PMC Response to:

Red Line Master Schedule 10.6
EMC Review-Ver 1.0

Parsons Brinckerhoff
Azrieli Center – Holon 1 Building A, 8th Floor
26 Harokmim Street
Holon, Israel 5885839

Figure 1 – Table form EMC report Section 1.13.3

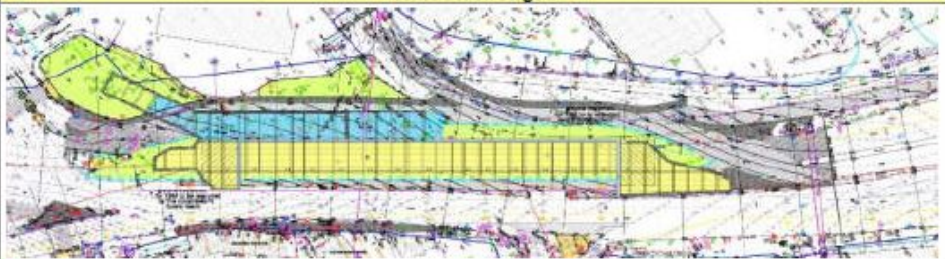
The critical path of the project's timetable goes through the underground stations. The progress of the works today shows significant delays in the construction of the stations. Since Completion of the D walls in each station is mandatory before beginning of the excavation works, EMC is identifying risk as result of the current delays and deviations of the actual works from its targets set in Schedule 10.6. This risk may be mitigated and the mitigation plan should be reviewed and approved by GOI. It should include buffers for future problems and additional time should be allocated to un-scheduled activities related to the mitigation plan, such as water treatment and reinforcement struts.

The PMC points out that the dates from the EMC table below taken from Section 1.1.3. are not the 10.6 baseline dates for completion of D-Walls. The PMC is unclear where these dates originated but suspects they may be for the Contractor's baseline.

For example referring to Yehudit station, the image below is taken from the September monthly report. Note the 10.6 baseline date for completion of D-Walls is Aug-2017 not May-2017. The PMC has found other inconsistencies in the above table e.g. Shaul Hamelach station D-Wall completion EMC - Jan-2017 vs. PMC September monthly - June-2017.
